# KANEPACKAGE PHILIPPINE INC.

## INVESTIGATION REPORT FORM (IRF)

Customer	CANON
Item Code	RJ1-0921
Item Description	CASSETTE ASSY OUTER BOX
Job Order Number	WO-F-20-094-1

## INVESTIGATION REPORT FOR FLAP GAP OF CBMP RJ1-0921 CASSETTE ASSY OUTER BOX

### ILLUSTRATION OF THE PROBLEM

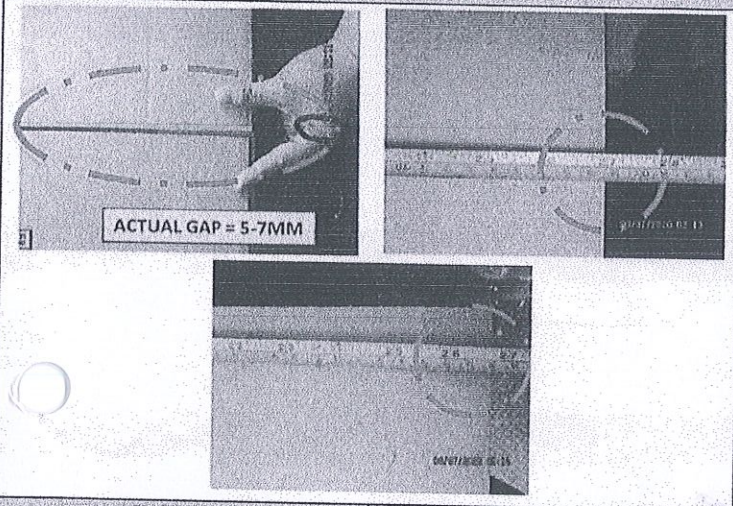
Nature of Defect:

FLAP GAP

Flap should be closed and no gap

Upper flap and lower flap has a gap of 5~7mm

~ Based on the actual sample dimension, all measure-  
ments are good / within tolerance.  
~ The inner dimension of the item increase to  
3mm (from 501mm req. to 504mm) and causes  
flap gap

~ Orientation to EQOS Operators & QA Patrol  
~ change design from 2joints to 1joint
